Access Compliance Report

Public Rights-of-Way

(Curb Ramps)

Intersection ID: 43512	Main Street: BLUEBERRY_HOLLOW_PL	Cross Street: VICTORIA_BROOK_LN	Location: E
ADA ID: C663EDAB50FD	Ramp Type: Perp	Initial Pass/Fail: Fail	Overall Compliance: No
Severity Score: 13.75			
Codes/Mitigation Info/Possible Solution		Field Measurements/Component Compliance

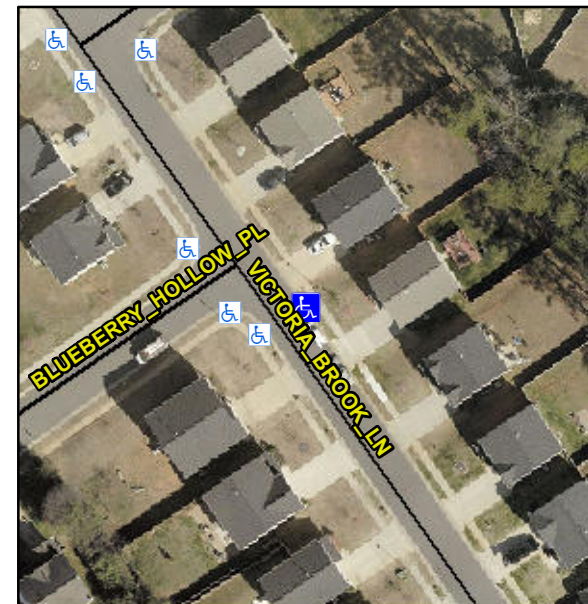
Not Found, R304.2.2

Compliance	Description	Data	Compliance	Description	Data
N/A	Ramp Length (in)	45.0	No	Ramp Slope (%)	8.9
Yes	Ramp Width (in)	48.0	Yes	Ramp XSlope (%)	3.1
N/A	Flare Type LT	N/A	N/A	Flare Type RT	N/A
N/A	Flare Slope LT (%)	N/A	N/A	Flare Slope RT (%)	N/A
N/A	Flare Traversable LT?	N/A	N/A	Flare Traversable RT?	N/A
N/A	Landing Length (in)	N/A	N/A	DWS Provided?	N/A
N/A	Landing Width (in)	N/A	N/A	DWS Contrast?	N/A
N/A	Landing Slope (%)	N/A	N/A	DWS Length (in)	N/A
N/A	Landing X Slope (%)	N/A	N/A	DWS Full Width?	N/A
N/A	Landing Curb? (Y/N)	N/A	N/A	DWS Offset (in)	N/A
N/A	Shared Landing?	N/A			
N/A	Gutter Ponding?	N/A	N/A	Gutter Slope (%)	N/A
N/A	Gutter Lip Ht (in)	N/A	N/A	Gutter X Slope (%)	N/A
N/A	Painted X Walk1?	No	N/A	Painted X Walk2?	N/A
	X Walk 1 Direction	To SW		X Walk 2 Direction	N/A
N/A	X Walk 1 Width (in)	N/A	N/A	X Walk 2 Width (in)	N/A
	X Walk 1 Slope (%)	2.8		X Walk 2 Slope (%)	N/A
	X Walk 1 X Slope (%)	3.2		X Walk 2 X Slope (%)	N/A

Remove & Replace Entire Ramp.
